SR	PART 1; MARINE PARADE SHARED PATH CONCEPT : Which is your preferred design solution to address the conflict between cyclists and pedestrians at the various beach access entry points?	PART 1; MARINE PARADE SHARED PATH CONCEPT : Thinking about your response to question 3 is there anything else you wish to add?
1	I do not support either option-	option 2 with caveat: path must have decreased speed limit per the shared zone (whatever that limit is...not stated anywhere in background info which is way too brief on detail for people to make informed responses) and path must be demarcated with lines along to direct traffic appropriately. Ideally paths should go around conflict zones as per the beach access/shower/water fountain across from Sydney St. People will be people and will get distracted and wonder across the conflict zones....
2	I do not support either option-	possibility of tripping on rumble strips

SR	Conflict Location 2: Dutch Inn Playground Frontage (beach side) : Is there anything else you think should beconsidered in this design?
1	Yes - Please provide additional feedback : Ideally path goes on streetside of playground. If not then path widened (2.5 m now) - there is no

Parking Bay Occupancy and Options (Near Sydney Street)

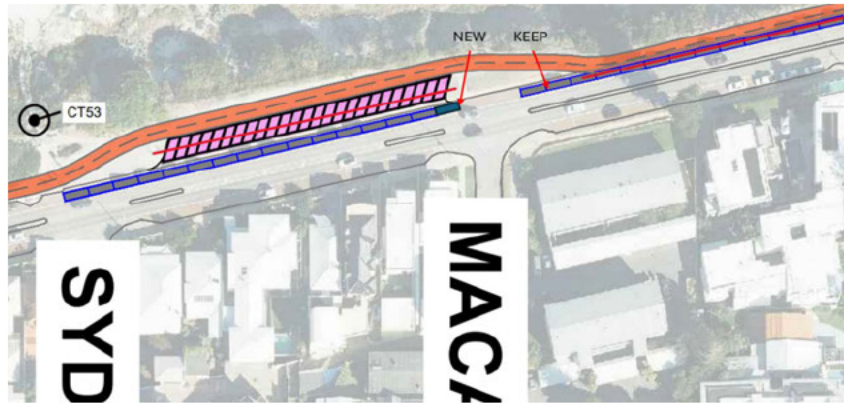
The 13 bays displaced by the bike path near Warton Road typically service Werne and the Gibney’s restaurant. If these bays are removed, then users will migrate to the side streets closer to their destination, rather than park near Sydney Street.

The council should consider the destination of users in when selecting area for to place any new bays (if new bays are needed at all). There is potential to add these on side streets such as Warton Road, removing vehicles from the busy Marine Parade. The road verge is wide in this area and it would not be considered a high traffic road as is Marine Parade. This is much safer when compared with creating a concentration of reversing cars along the very busy section of Marine Parade.

The current parking bay occupancy collectively from Sydney Street to Warton Road is actually very low. There are rare days in summer where parking bay occupancy is high, though they are rarely collectively filled. By optimising the parallel parking from Sydney to Macarthur Streets, that parking will be adequate for almost all instances, and the road safety
